HISTORIC AND DESIGN REVIEW COMMISSION

February 20, 2019

HDRC CASE NO: 2019-066
ADDRESS: 368 CLUB DR
LEGAL DESCRIPTION: NCB 6703 BLK 13 LOT 19 W 24 FEET OF 20
ZONING: R-6, H
CITY COUNCIL DIST.: 7
DISTRICT: Monticello Park Historic District
TYPE OF WORK: Carport Installation and Saltillo Tile Work
APPLICATION RECEIVED: February 06, 2019
60-DAY REVIEW: April 04, 2019
REQUEST:

The applicant is requesting a Certificate of Appropriateness for approval install a carport on the west side of the property on an existing circular drive abutting Shearer Blvd and encroaching on the public right-of-way.

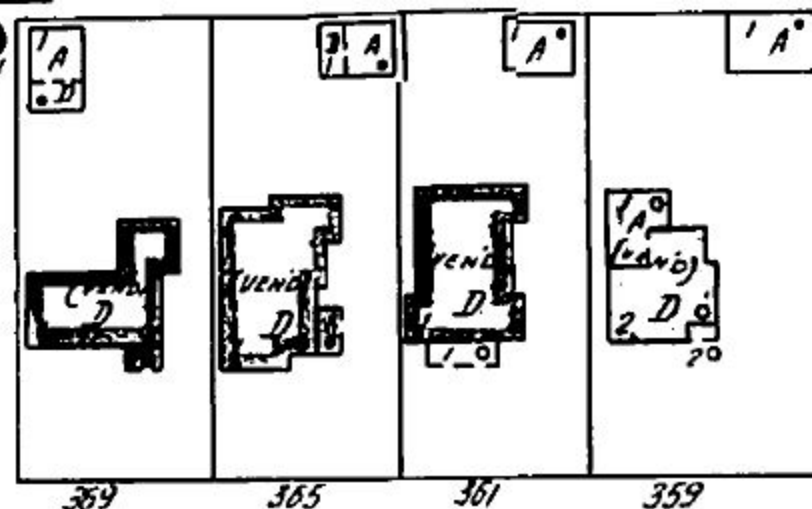
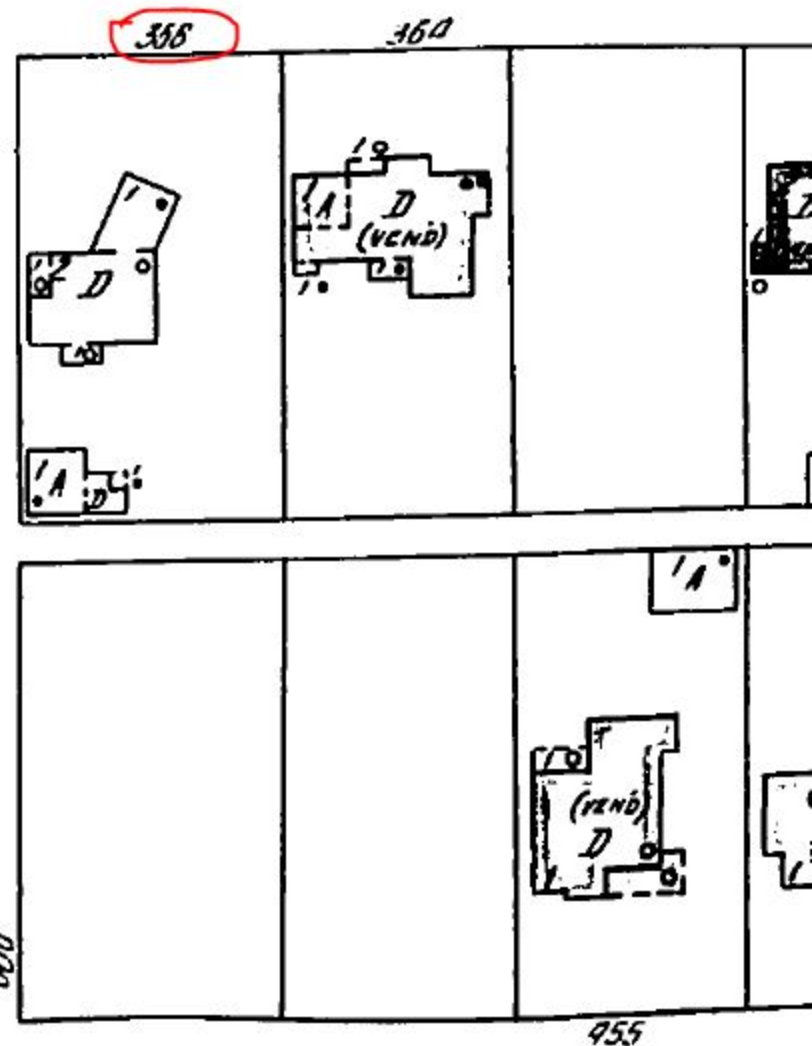
- f. **SETBACK AND ORIENTATION** – Per the Guidelines for New Construction 5.B.i, front-loaded garages or garages attached to the primary structure on blocks should not be introduced where rear or alley-loaded garages were historically used. Per the Guidelines 5.B.ii, new garages and outbuildings should follow historic setback pattern of similar structures along the streetscape or district. While the proposed carport is set to a side elevation, staff finds that a more appropriate location would be in the rear of the east side ribbon driveway rather than encroaching on public right-of way.

Staff does not recommend approval based on finding f. While staff finds that the design of the carport is generally appropriate, its location should instead be set to rear of the east side ribbon driveway rather than encroach on the west side public right-of-way.
